ST LEONARDS SOUTH

REPORT TO COUNCIL

REVIEW OF CHARRETTE & DPIE REPORT

April 2020

This section compares shadow generation in mid-winter between Council Proposal (upper) and Charrette Proposal (Lower).

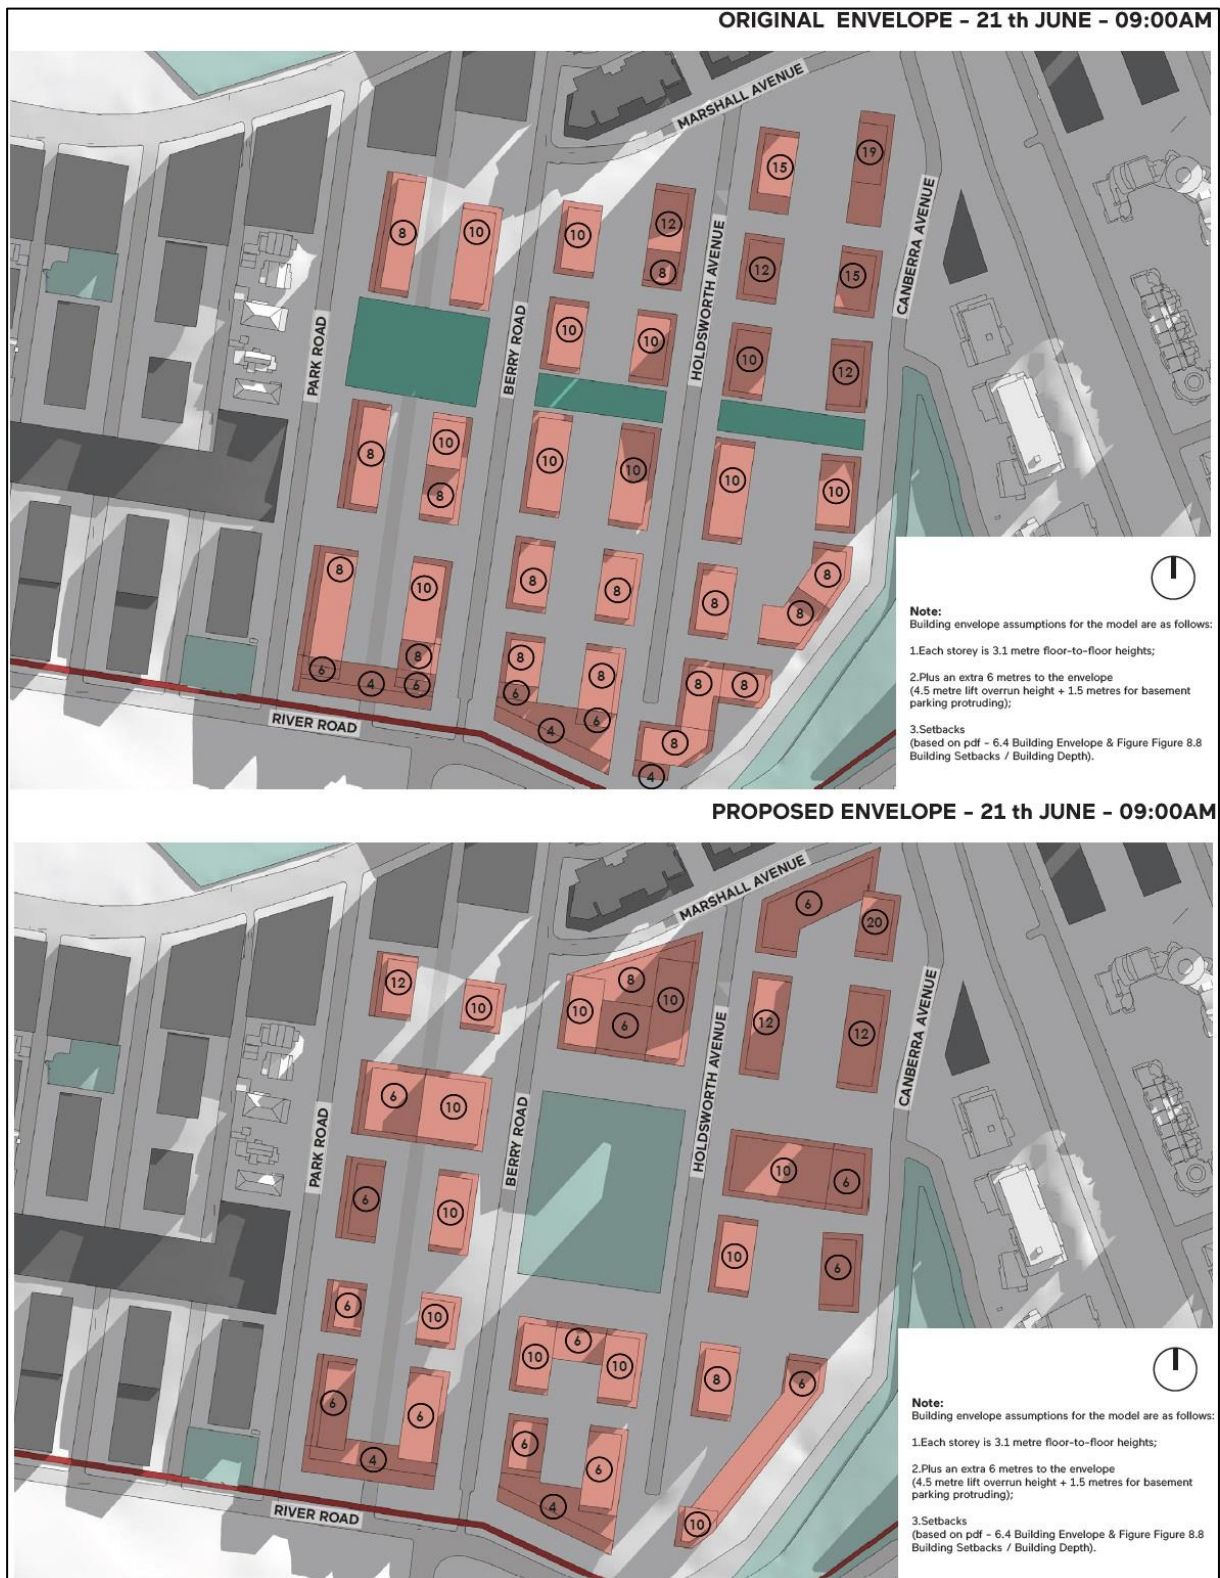
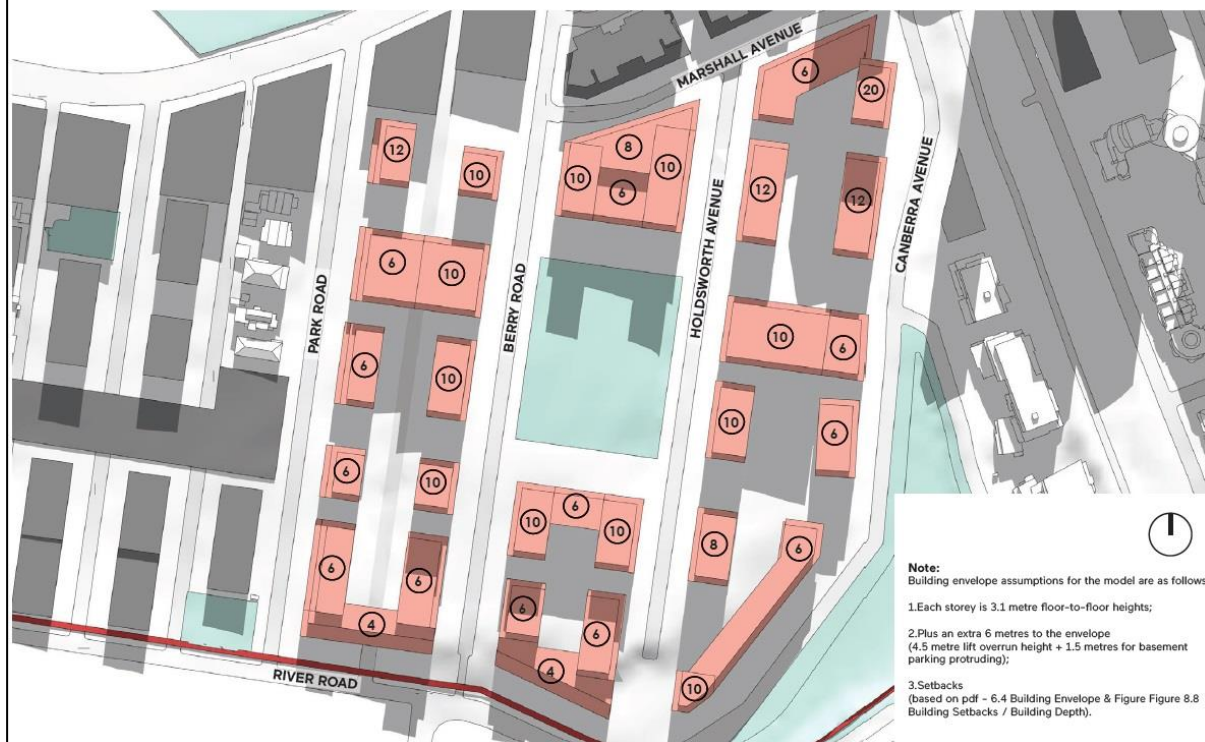
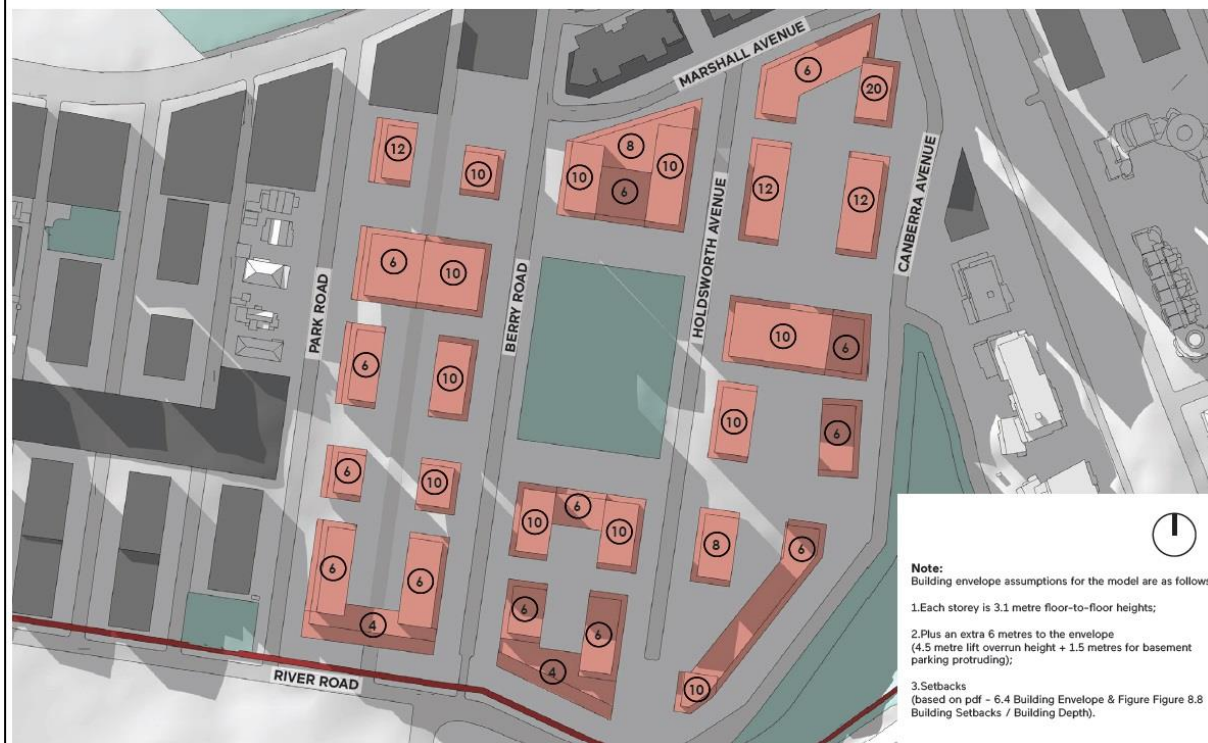
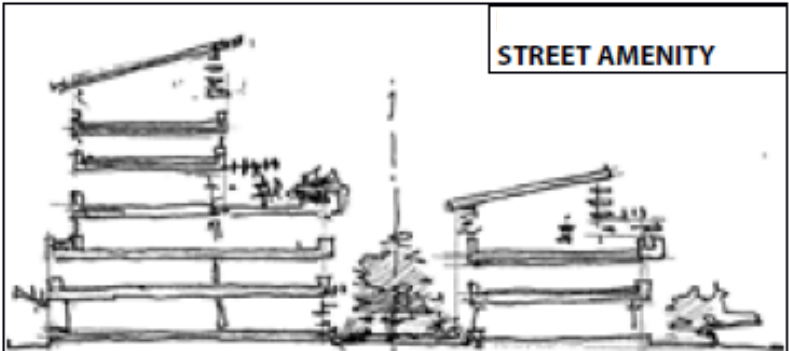
Note that solar access is similar for both Council's proposal and Charrette Proposal, except that the larger (and non-viable) park in the Charrette proposal provides greater solar access due to size.
